HISTORIC AND DESIGN REVIEW COMMISSION

October 06, 2021

HDRC CASE NO: 2021-444
ADDRESS: 114 BOSTON
LEGAL DESCRIPTION: NCB 578 BLK D LOT 3
ZONING: RM-4, H
CITY COUNCIL DIST.: 2
DISTRICT: Dignowity Hill Historic District
APPLICANT: jaime jimenez/Jaime Jimenez Idea Studio
OWNER: Miguel Galvan
TYPE OF WORK: Construction of an addition, roof modifications, site work, driveway installation
APPLICATION RECEIVED: August 30, 2021
60-DAY REVIEW: Not applicable due to City Council Emergency Orders
CASE MANAGER: Edward Hall

01 PROPOSED SITE PLAN

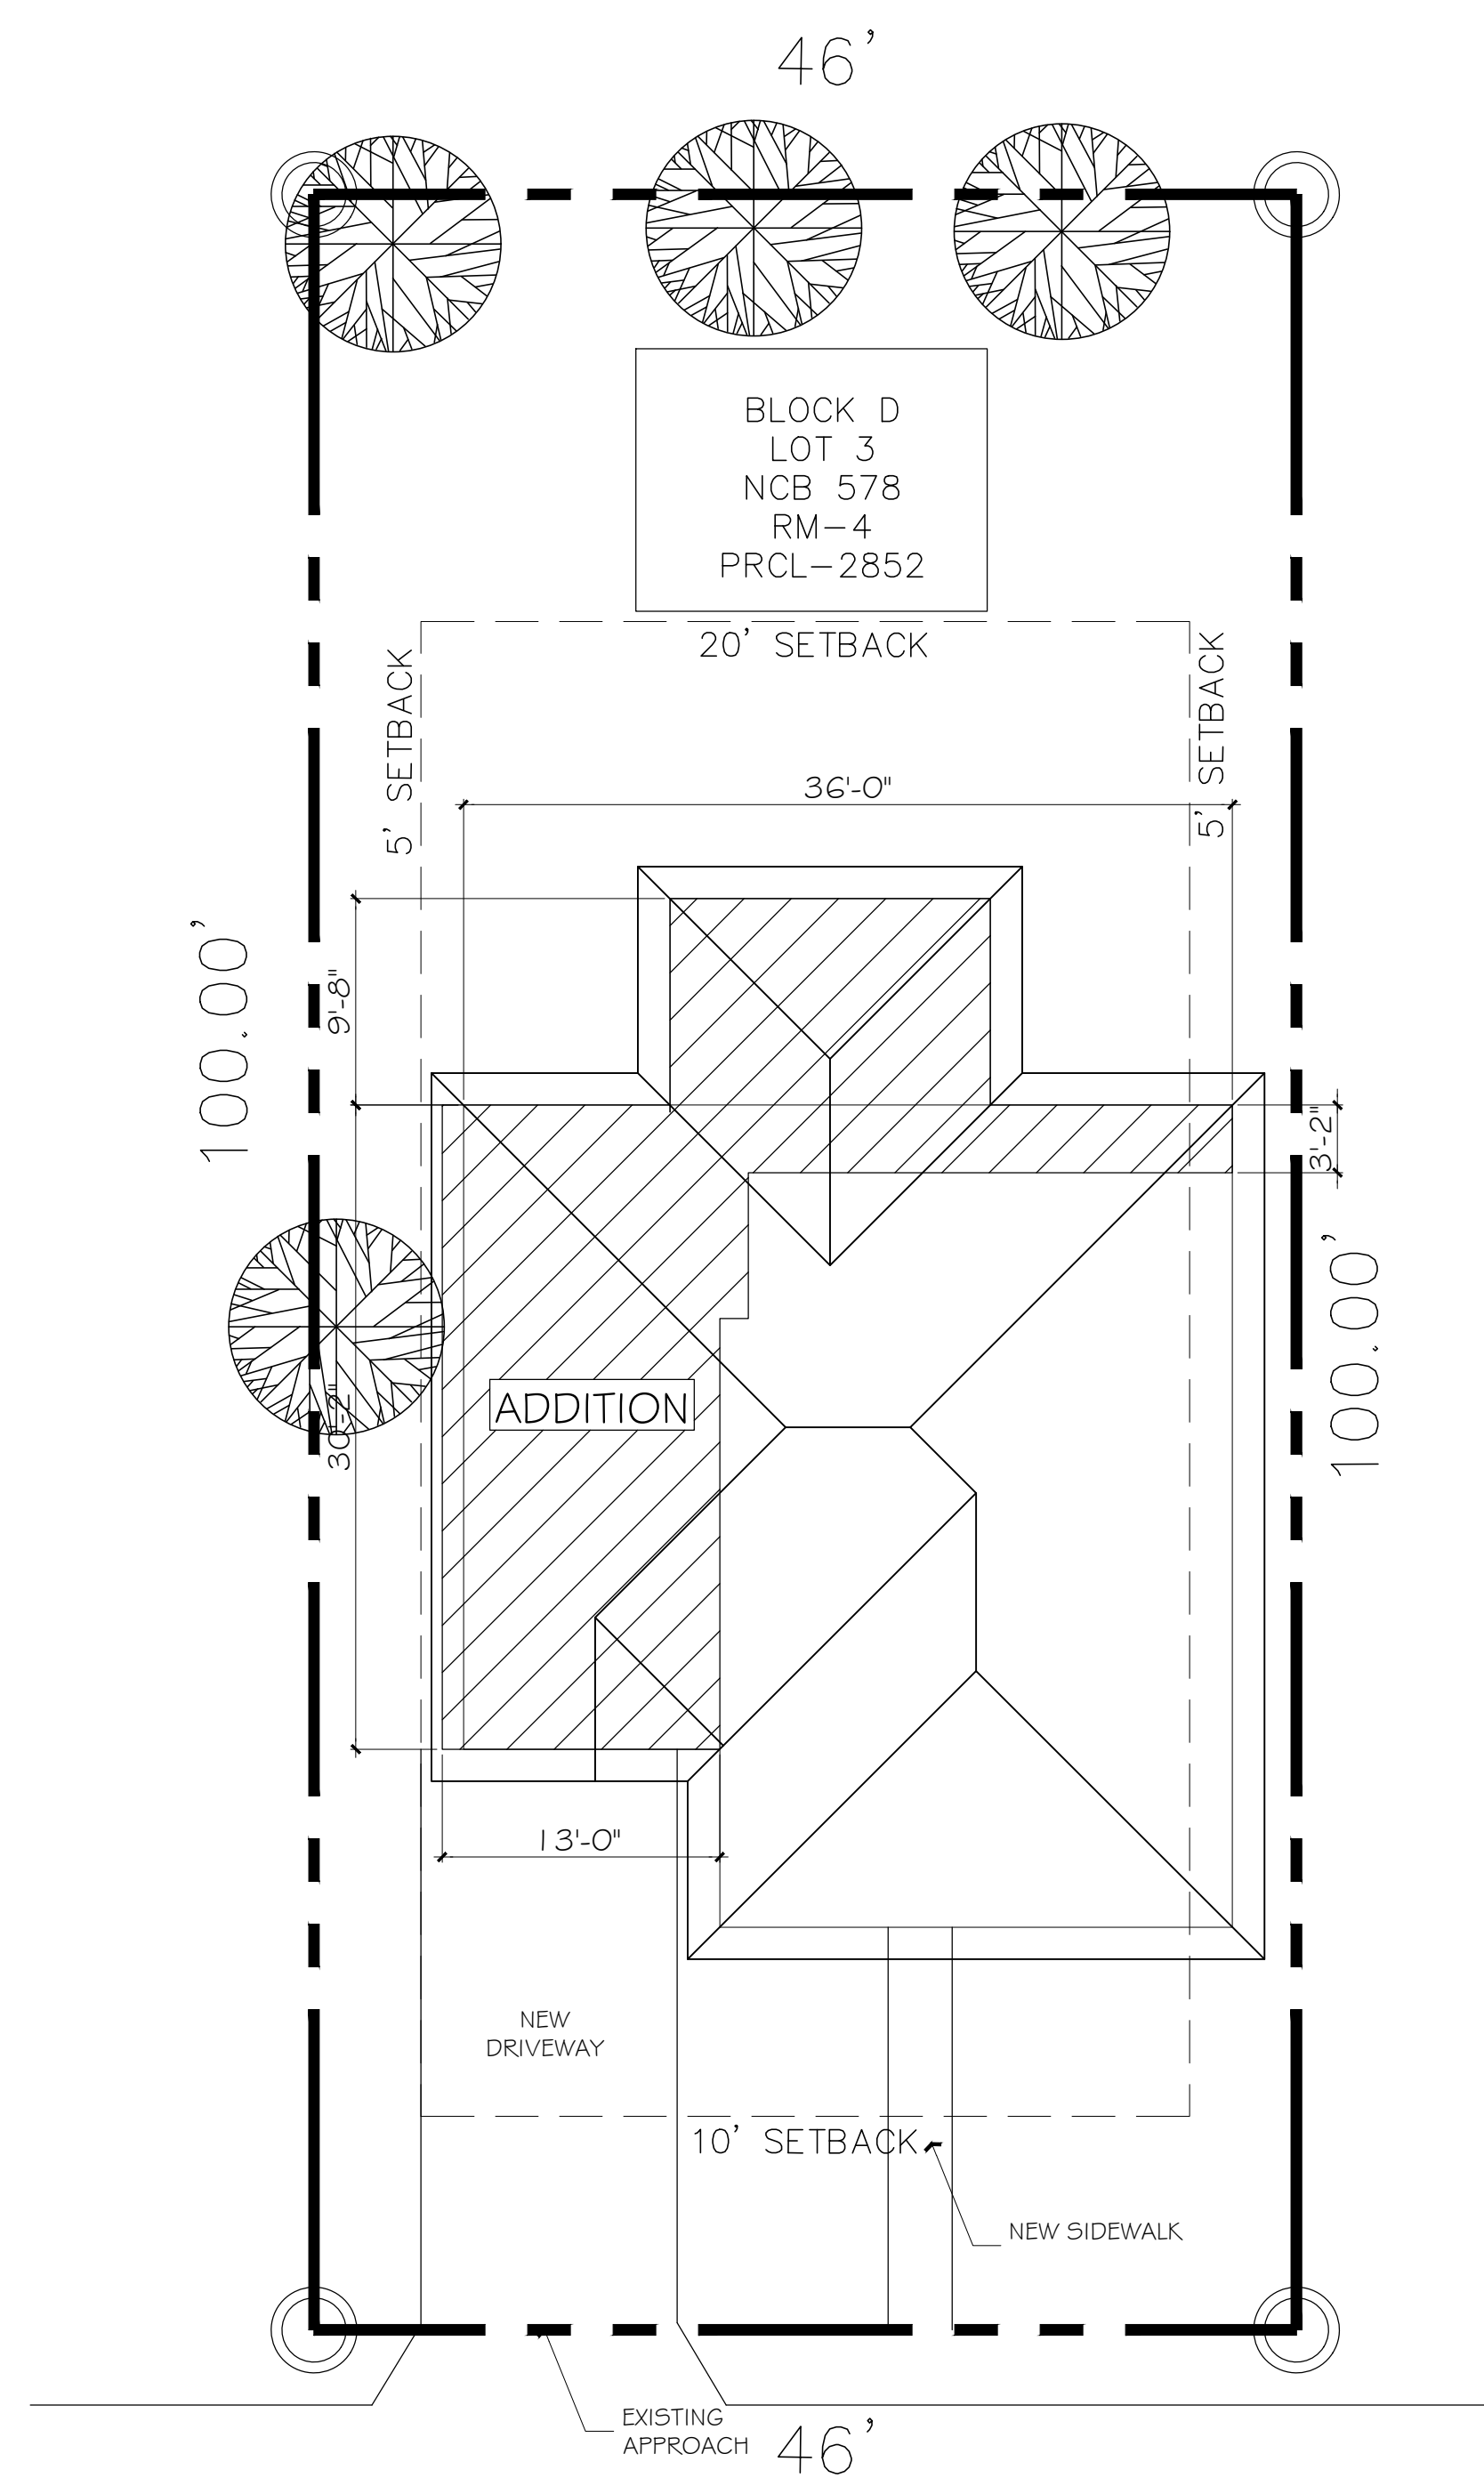
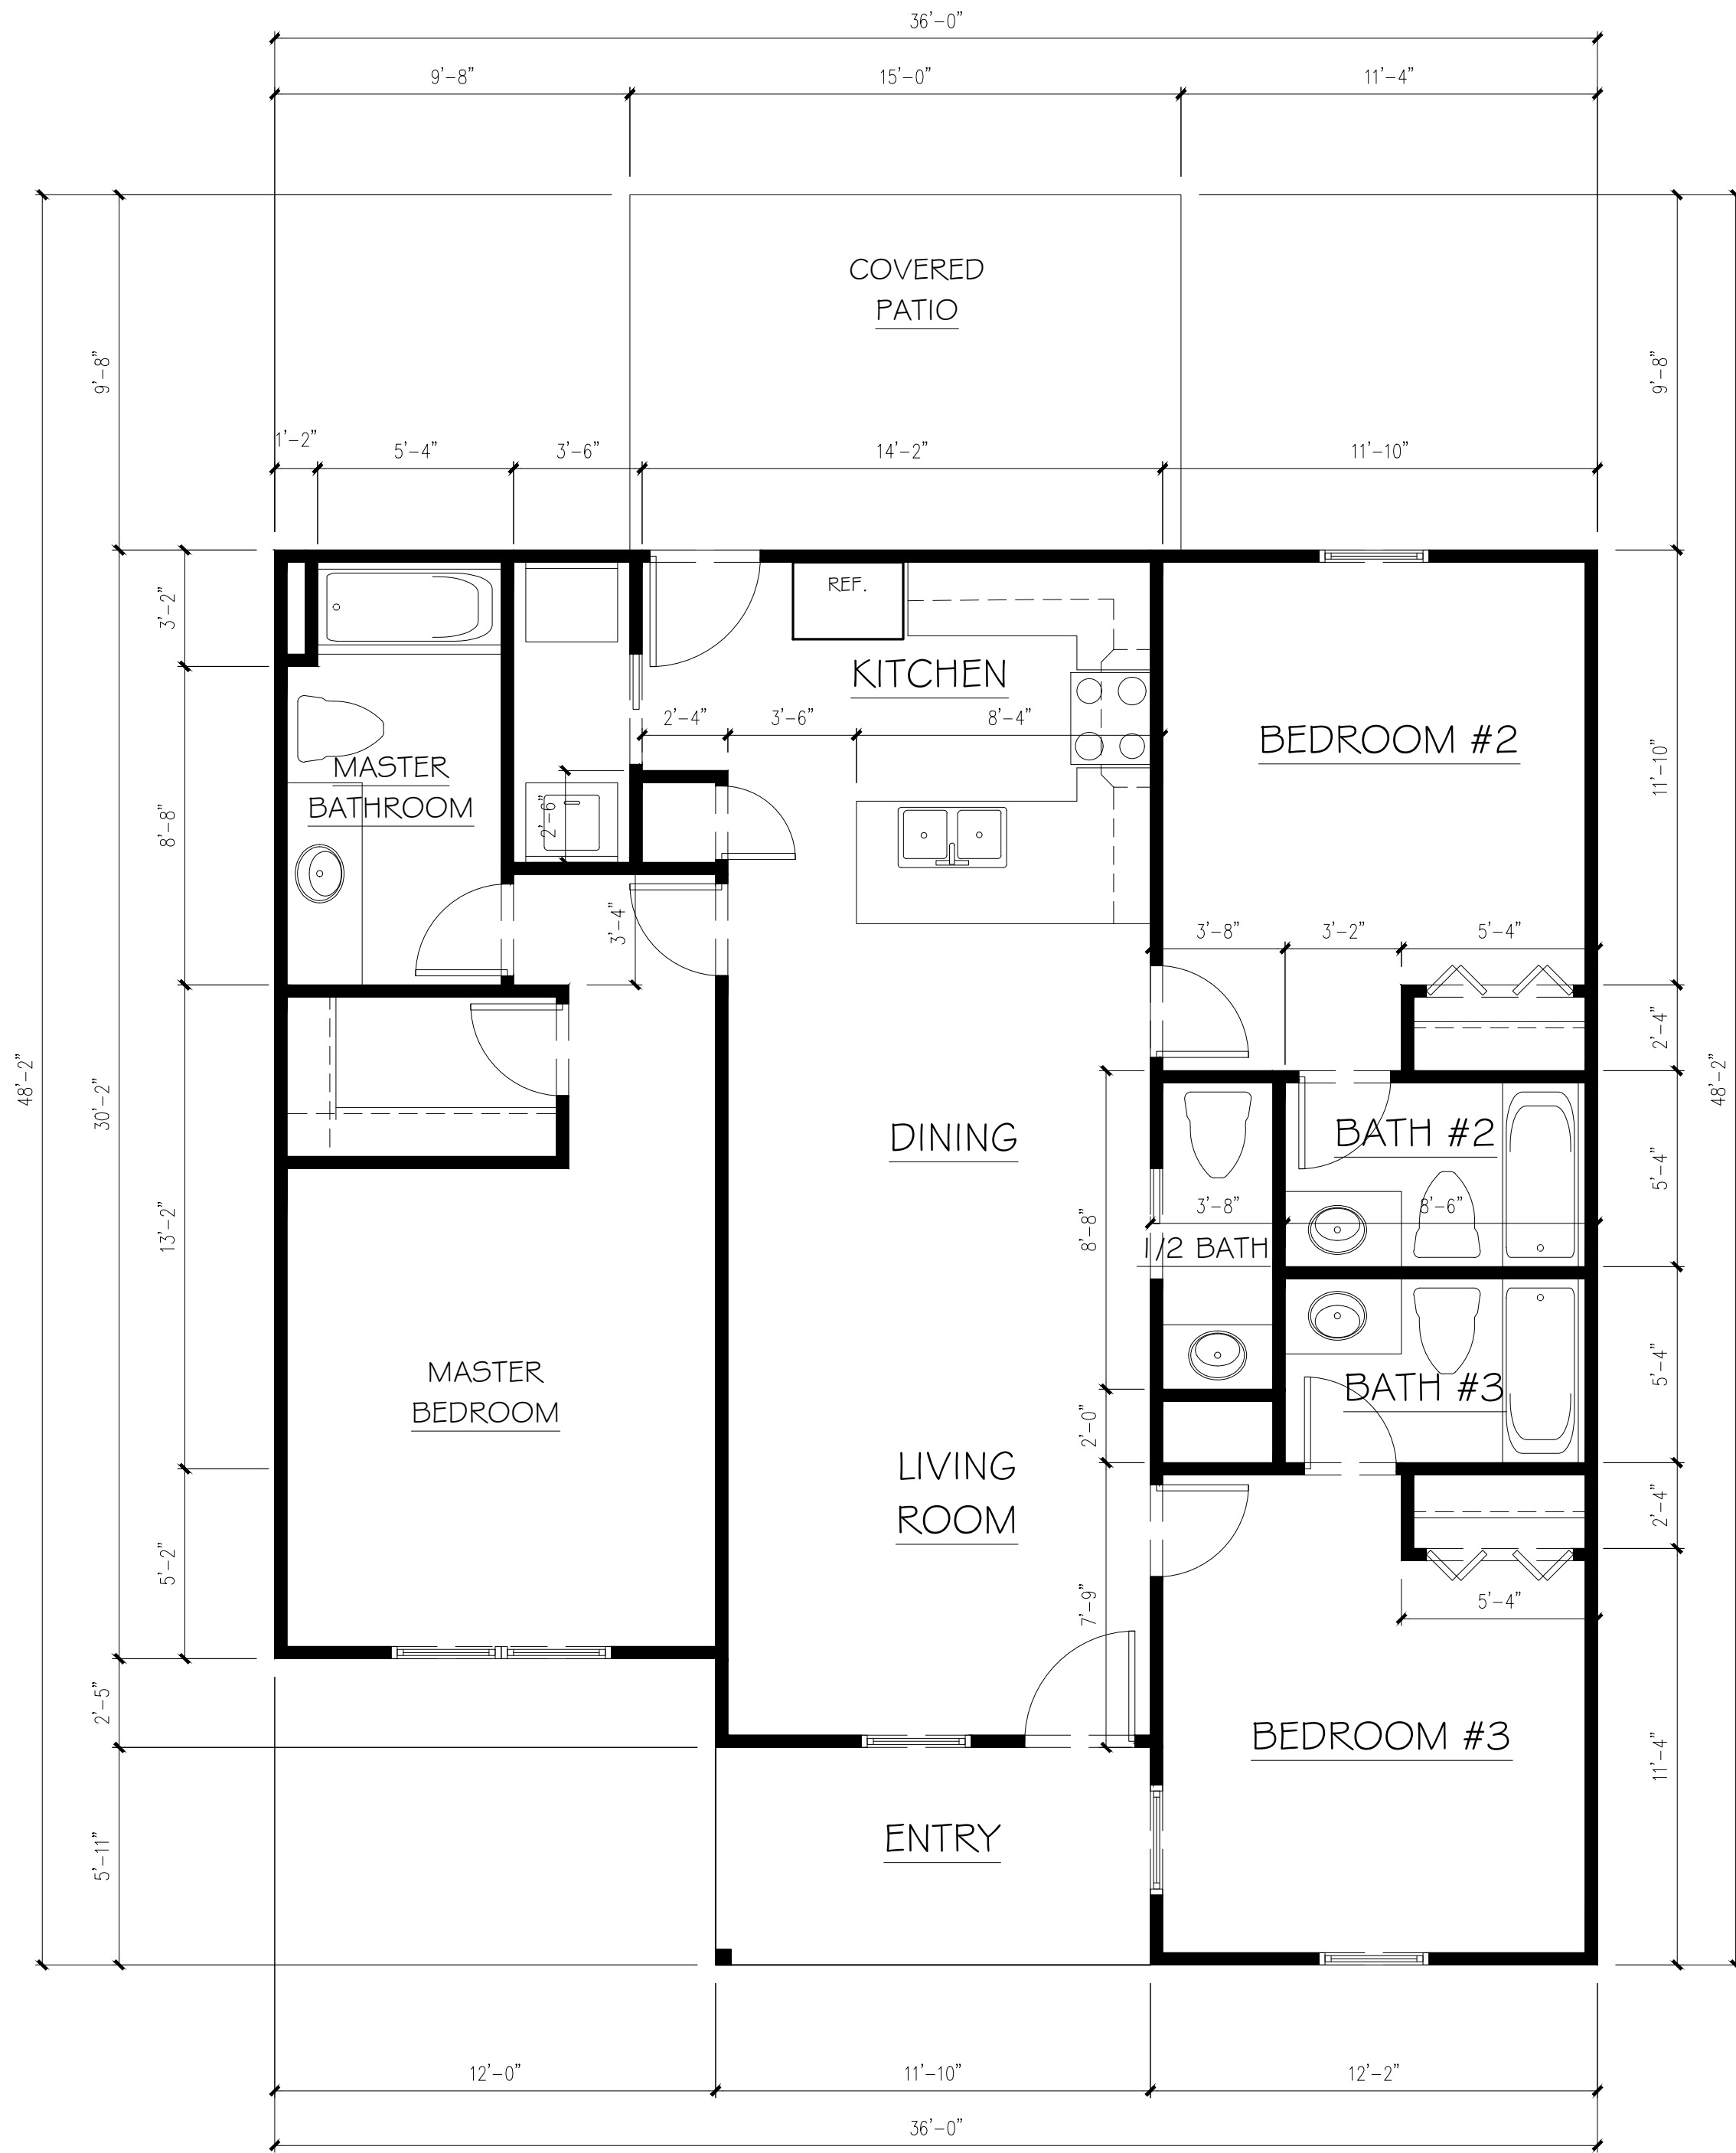
- g. WALKWAY – The applicant has proposed to replace the existing concrete walkway with a new concrete walkway. The existing concrete walkway is damaged and staff finds its replacement to be appropriate; however, staff finds that the existing profile should be maintained, including the flare at the front porch steps.
- h. DRIVEWAY – The applicant has proposed to install a solid concrete driveway where an existing ribbon strip driveway exists. The Guidelines for Site Elements note that new driveways should feature a similar configuration as those found historically within the district in regards to their materials, width and design. Staff finds that the existing ribbon strip profile should be maintained.

1. Staff does not recommend approval of item #1, the construction of an addition, based on findings c through f. Staff recommends that the addition should primarily be located at the rear of the historic structure, should not increase the massing in width of the historic structure, and should feature materials and architectural details that are consistent with those found on the historic structure.
2. Staff recommends approval of item #2, the replacement of the existing concrete walkway provided that it is replaced in-kind, with a matching profile, based on finding g.
3. Staff does not recommend approval of item #3, the replacement of the existing concrete ribbon strip driveway with a solid concrete driveway, based on finding h.
